NAVIGATION - STALL WARNING HORN REPLACEMENT

MODEL	SERIAL NUMBERS
310Q/T310Q	310Q0460 thru 310Q1160
310R/T310R	310R0001 thru 310R2140

The original stall warning horn is no longer available. If the stall warning horn needs to be replaced, a new stall warning horn is available and will require an additional bracket for installation.

MEB-34-05
Page 1 of 23

Figure 3. 310Q Configuration 1 (Sheet 1)

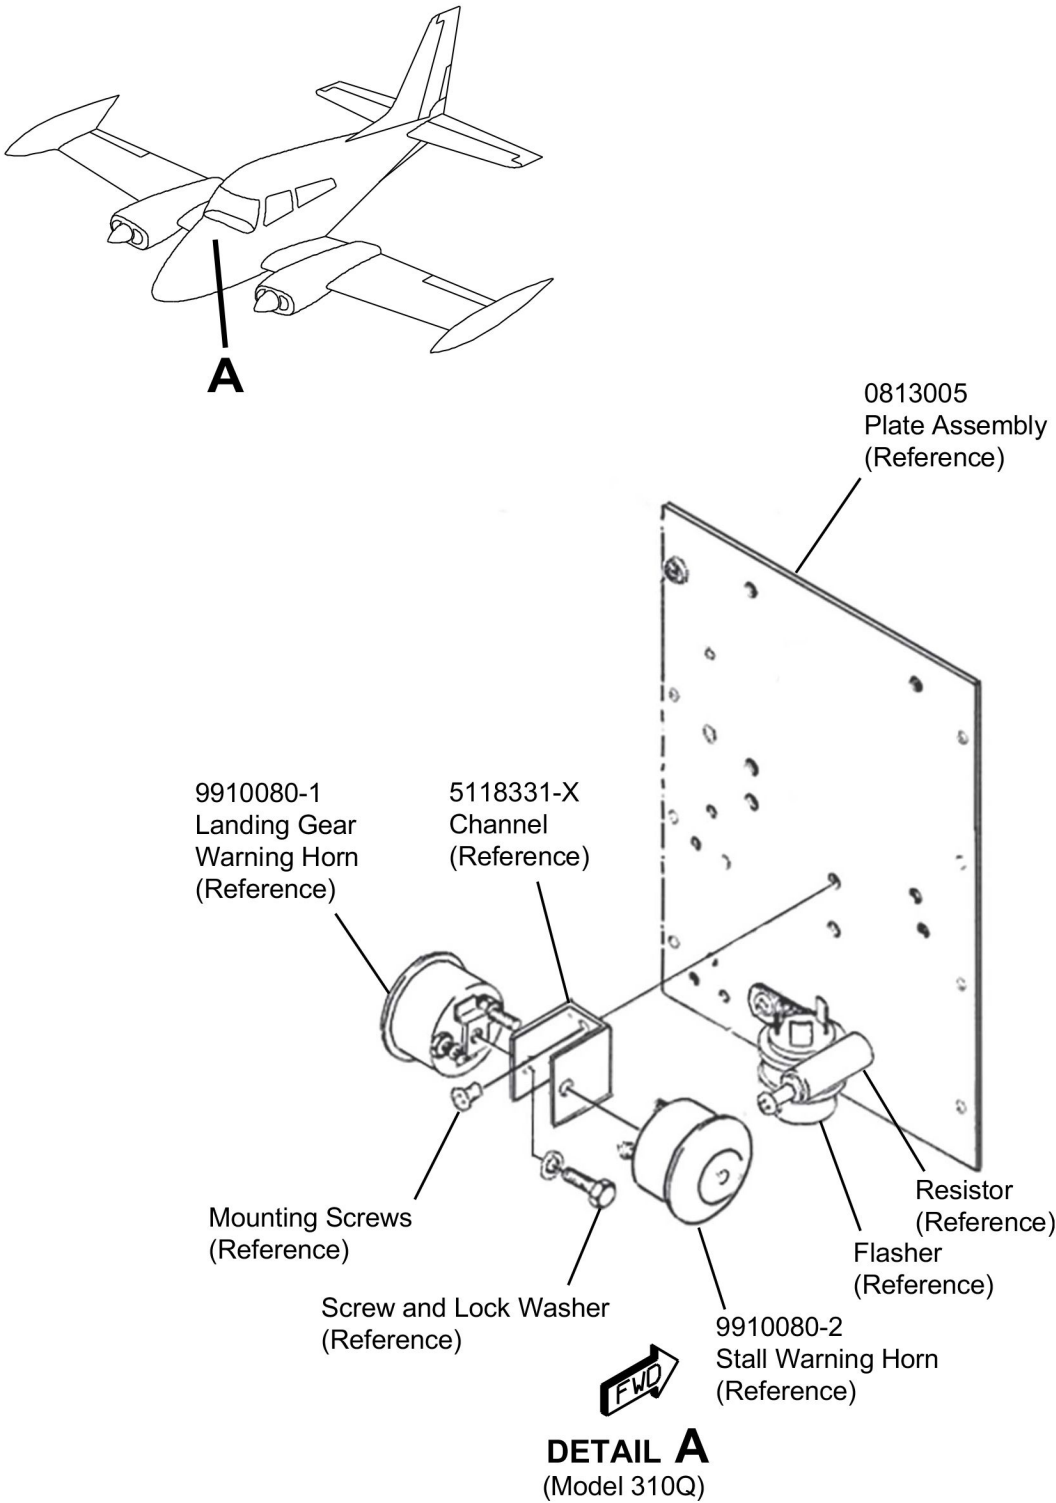
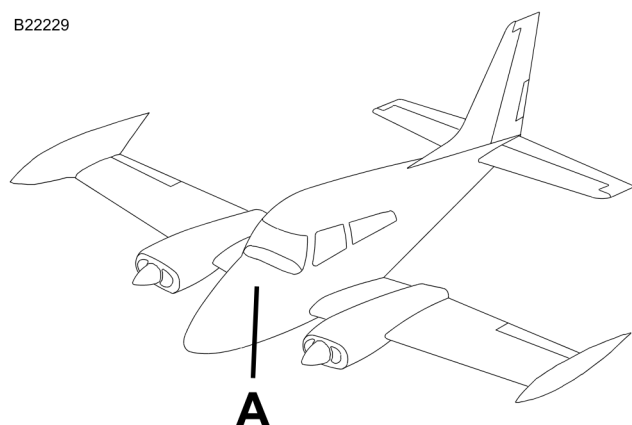
3. (For Model 310Q Refer to Figure 1, Sheet 1, and for Model 310R Figure 2, Sheet 1.) Remove the 9910080-2 Stall Warning Horn as follows:
- A. Remove and discard the screw and lock washer from the 9910080-1 Landing Gear Warning Horn.

- J. Discard the 5118331-X Channel.
4. (For Model 310Q Refer to Figure 3, Sheet 1 and 2, and for Model 310R Figure 4, Sheet 1 and 2.) Install the 9910080-6 Stall Warning Horn as follows:

- A. Install the 9910080-5 Landing Gear Warning Horn. (Refer to MEB-32-01: Landing Gear Warning Horn Replacement, **CONFIGURATION 1**.)
- B. Install the 9910080-6 Stall Warning Horn into the 5290604-5 Bracket.
- C. Install the knurled nut onto the 9910080-6 Stall Warning Horn.

NOTE: The plastic knurled nut must be installed with the three indents toward the bracket and horn assembly. On the internal circumference, the smooth side without threads is installed first, towards the bracket and horn. This technique of installation will make sure the nut fully seats against the bracket and not bottom-out on the threads. If not installed correctly the knurled nut will bottom-out on the threads and the horn assembly will not be fully tightened in the bracket.

Figure 5. 310Q Configuration 2 (Sheet 2)

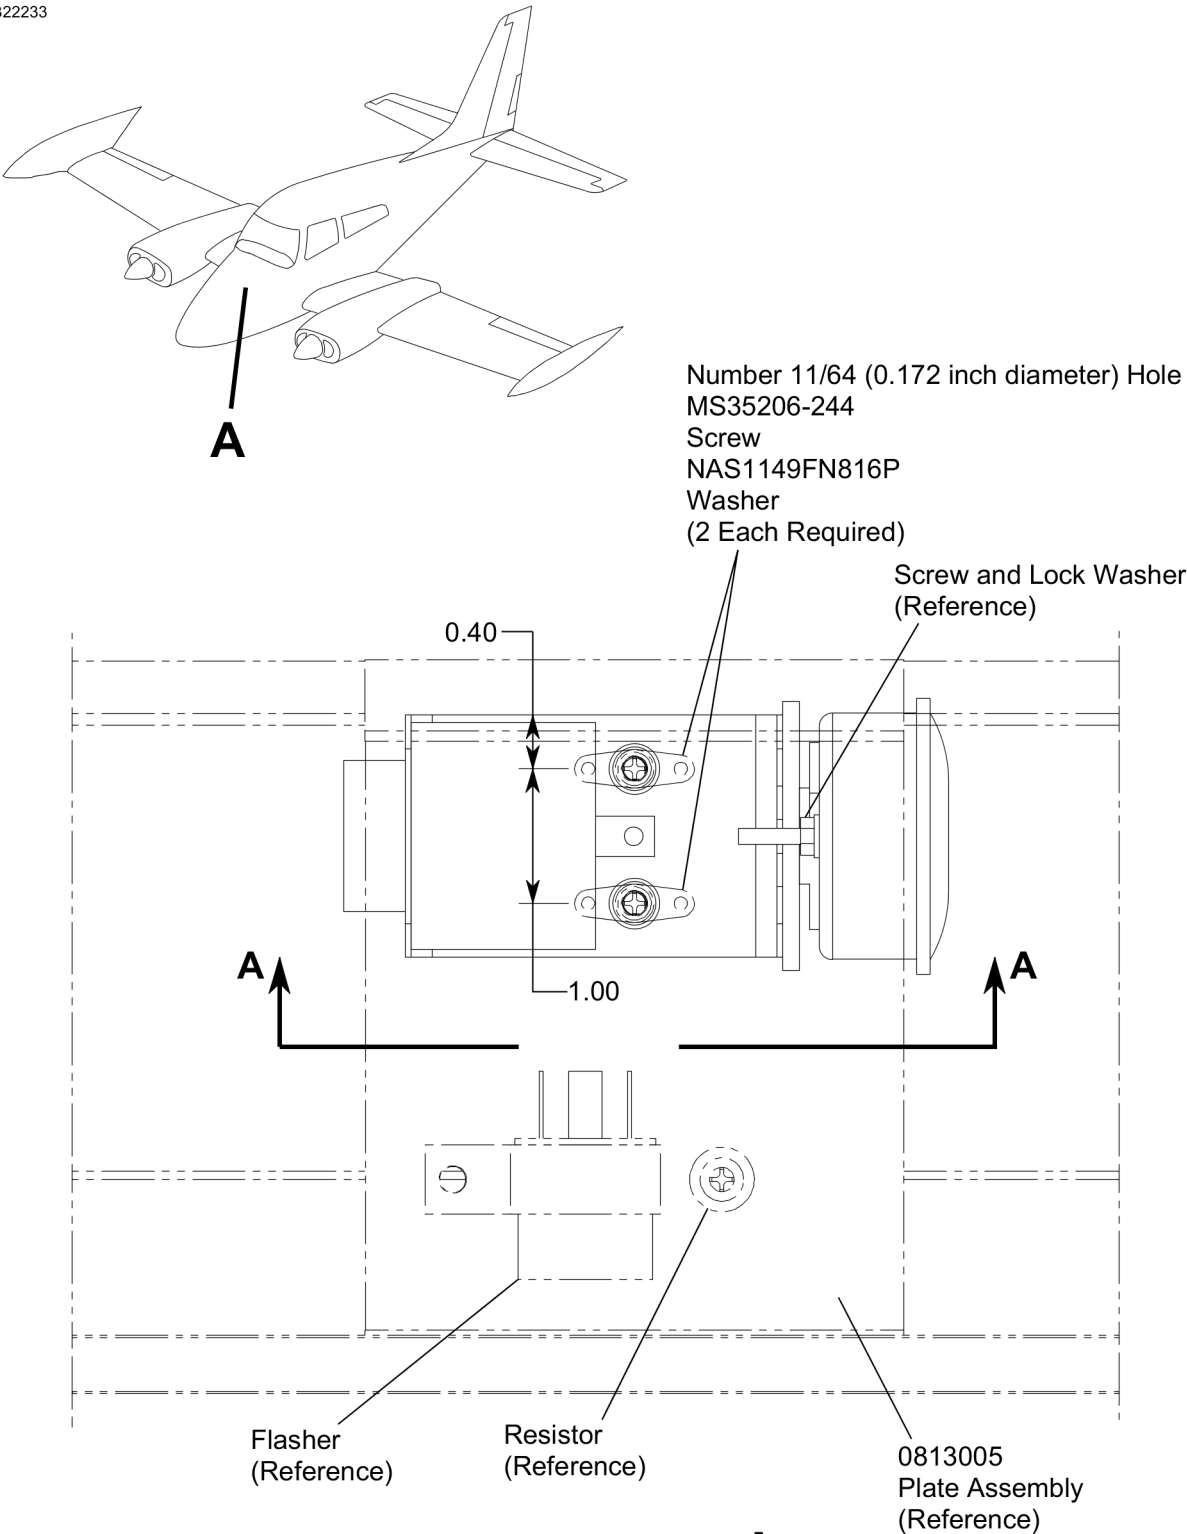
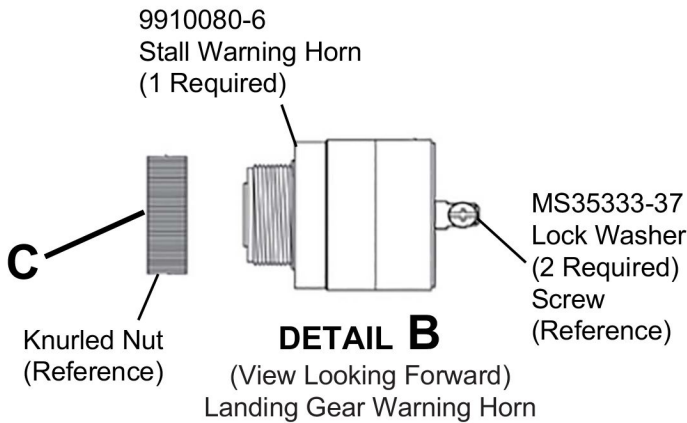
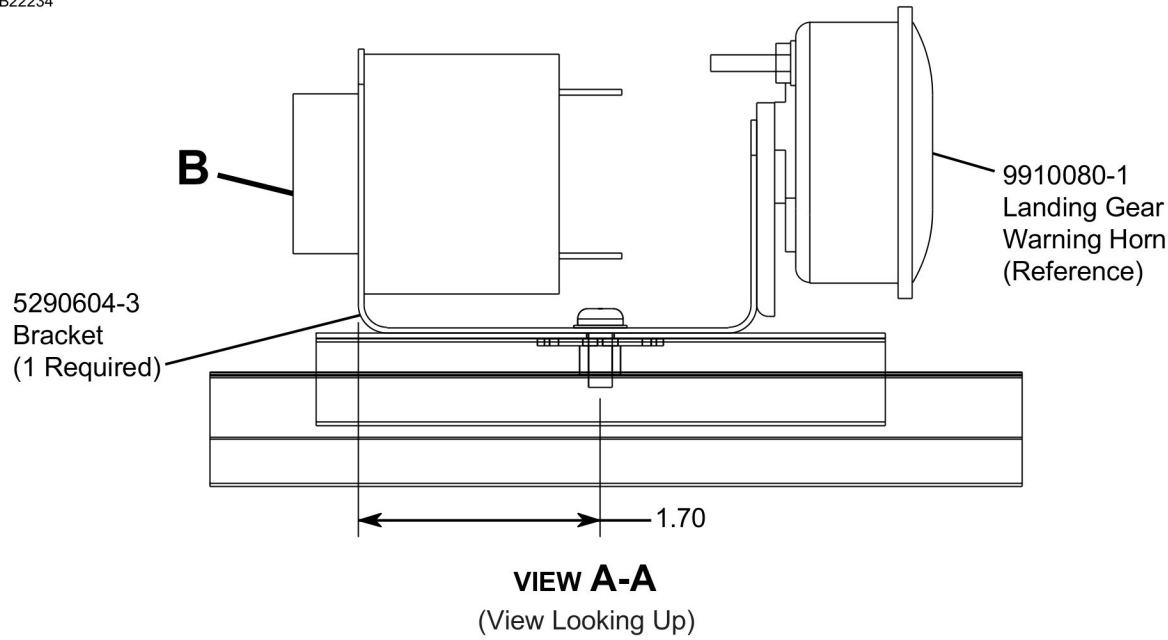
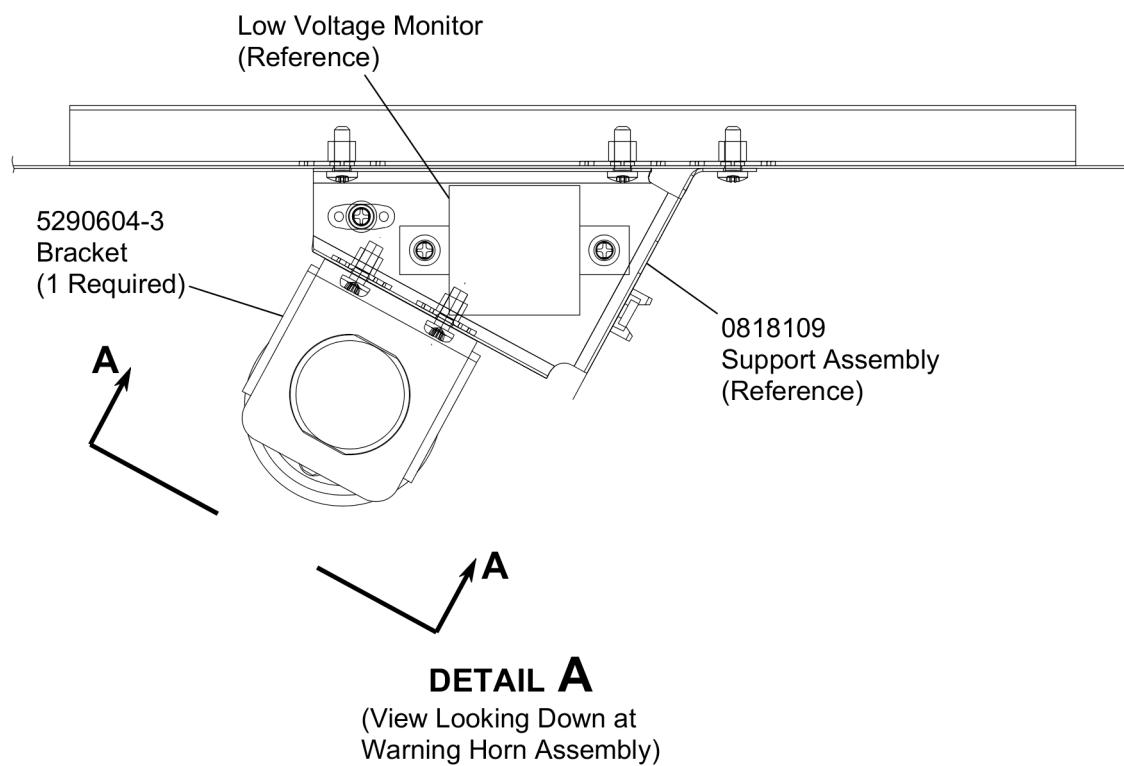
- G. Remove and discard the mounting screws from the 5118331-X Channel.
 - H. Discard the 5118331-X Channel.
8. (For Model 310Q Refer to Figure 5, Sheet 1 and 2, and for Model 310R Figure 6, Sheet 1 and 2.) Install the 9910080-6 Stall Warning Horn as follows:

- A. (For Model 310Q airplanes.) Match drill the two Number 11/64 (0.172 inch diameter) holes of the 0813005 Plate Assembly to the 5290604-3 Bracket.
 - (1) Debur the drilled holes from the 5290604-3 Bracket.

- (1) Debur the drilled holes from the 5290604-3 Bracket.
 - (2) Apply Color Chemical Film Treatment to all bare metal.
 - C. Install the 5290604-3 Bracket with the two MS35206-244 Screws and the two NAS1149FN816P Washers into the 0813005 Plate Assembly or the 0818109 Support Assembly.

- D. Install the 9910080-6 Stall Warning Horn into the 5290604-3 Bracket.
 - E. Install the knurled nut onto the 9910080-6 Stall Warning Horn.

NOTE: The plastic knurled nut must be installed with the three indents toward the bracket and horn assembly. On the internal circumference, the smooth side without threads is installed first, towards the bracket and horn. This technique of installation will make sure the nut fully seats against the bracket and not bottom-out on the threads. If not installed correctly the knurled nut will bottom-out on the threads and the horn assembly will not be fully tightened in the bracket.

Figure 6. 310R Configuration 2 (Sheet 2)

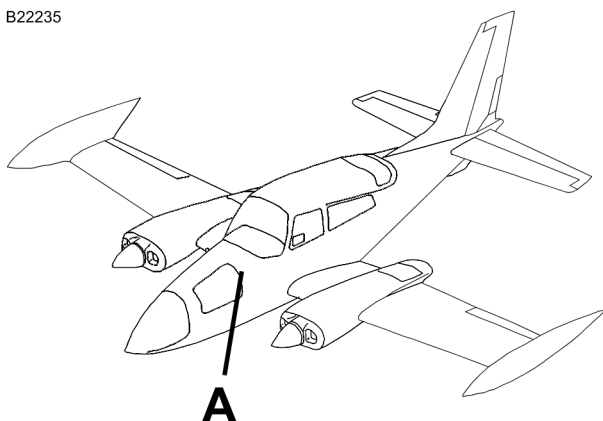
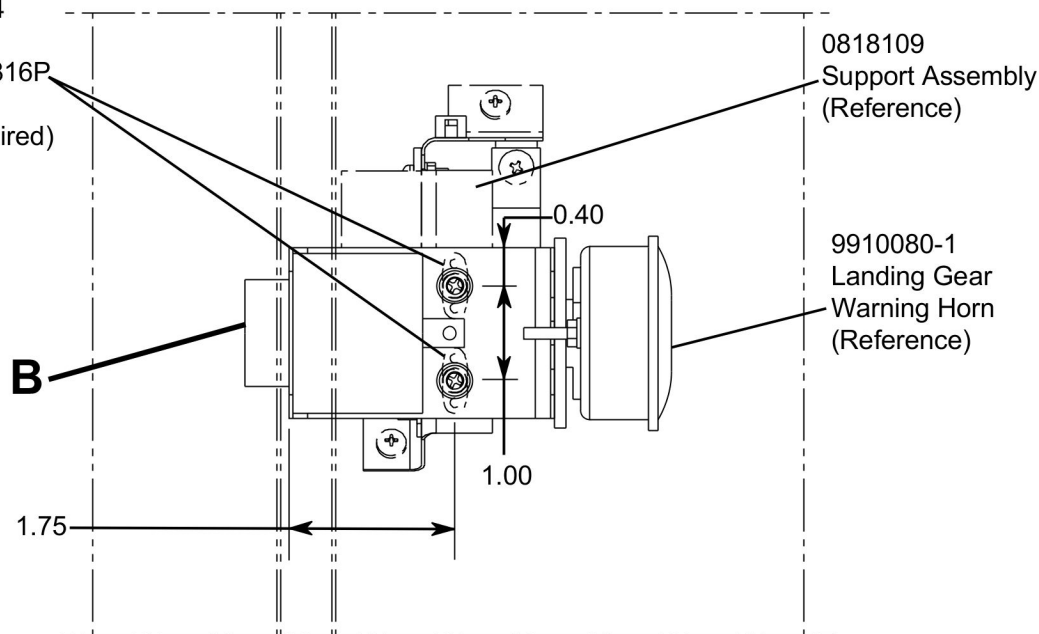
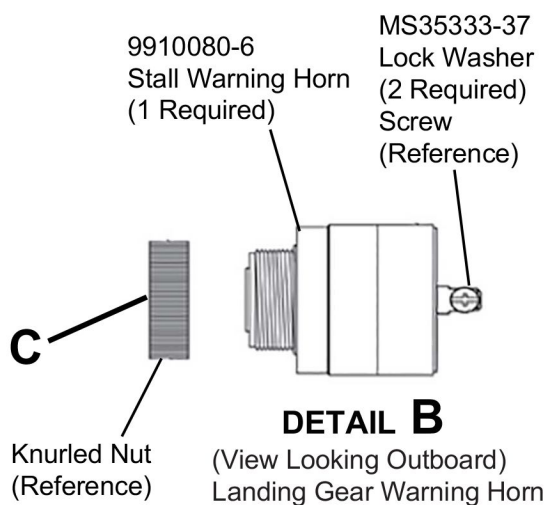
- (2) Apply Color Chemical Film Treatment to all bare metal.
 - (3) Go to Step 8C.
 - B. (For Model 310R airplanes.) Match drill the two Number 11/64 (0.172 inch diameter) holes of the 0818109 Support Assembly to the 5290604-3 Bracket.
